Access Compliance Report Public Rights-of-Way (Curb Ramps)

Intersection ID: 5778 Main Street: JOHN_KIRK_DR Cross Street: MARGIE_ANN_DR Location: ADA ID: E274457B7C1B Ramp Type: Perp Initial Pass/Fail: Fail **Overall Compliance: No** Severity Score: 13.75

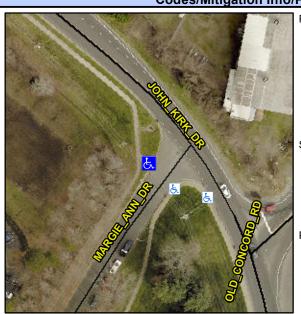
MARGIE ANN DR Street 1 Name Stop Condition-Street 2 StopSign Street 2 Name N/A Stop Condition-Street 1 N/A Possible Solutions: Remove & Replace Entire Ramp. Surveyor Notes: N/A PROW/ADA: Not Found, R304.2.2, R304.5.3

Field Measurements/Component Compliance					
Compliance Description		Data	Comp	liance Description	Data
N/A	Ramp Length (in)	40.0	No	Ramp Slope (%)	9.8
Yes	Ramp Width (in)	48.0	No	Ramp XSlope (%)	2.8
N/A	Flare Type LT	N/A	N/A	Flare Type RT	N/A
N/A	Flare Slope LT (%)	N/A	N/A	Flare Slope RT (%)	N/A
N/A	Flare Traversable LT?	N/A	N/A	Flare Traversable RT?	N/A
N/A	Landing Length (in)	N/A	N/A	DWS Provided?	N/A
N/A	Landing Width (in)	N/A	N/A	DWS Contrast?	N/A
N/A	Landing Slope (%)	N/A	N/A	DWS Length (in)	N/A
N/A	Landing X Slope (%)	N/A	N/A	DWS Full Width?	N/A
N/A	Landing Curb? (Y/N)	N/A	N/A	DWS Offset (in)	N/A
N/A	Shared Landing?	N/A			
N/A	Gutter Ponding?	N/A	N/A	Gutter Slope (%)	N/A
N/A	Gutter Lip Ht (in)	N/A	N/A	Gutter X Slope (%)	N/A
N/A	Painted X Walk1?	No	N/A	Painted X Walk2?	N/A
	X Walk 1 Direction	To SE		X Walk 2 Direction	N/A
N/A	X Walk 1 Width (in)	N/A	N/A	X Walk 2 Width (in)	N/A
	X Walk 1 Slope (%)	0.4		X Walk 2 Slope (%)	N/A
